33519B-02

# Modification Recommended Service Note

## 33519B Function Generator

Serial Numbers: MY000000000 to MY57500600 and SG000000000 to SG57500600

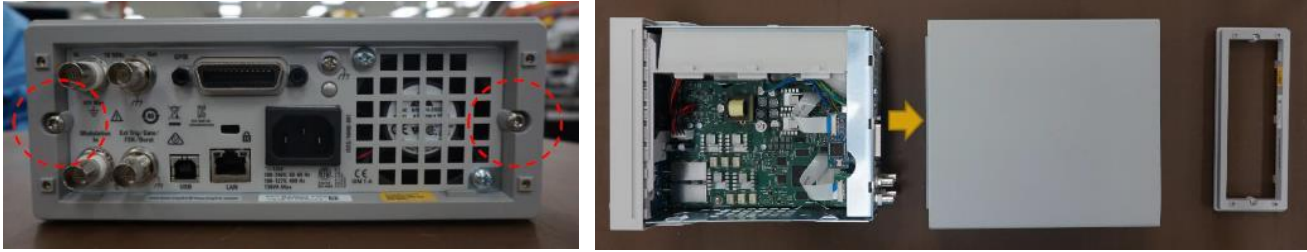
**The Problem** – Some customers have reported that, when line power is applied to the instrument but the instrument is NOT turned on (“Standby Mode”), some instruments will emit an audible high-pitched whistle or whine. To fix this, the existing power supply must be replaced with a newly designed power supply, as detailed in the solution below.

**Old Noisy XP Power Supply (PN xxxx-xxxx)**

**New MeanWell Power Supply (PN 0950-6082)**

The solution is to replace the old power supply with a new one. The old power supply was manufactured by XP Power. The new power supply is manufactured by MeanWell, and has Part Number 0950-6082.
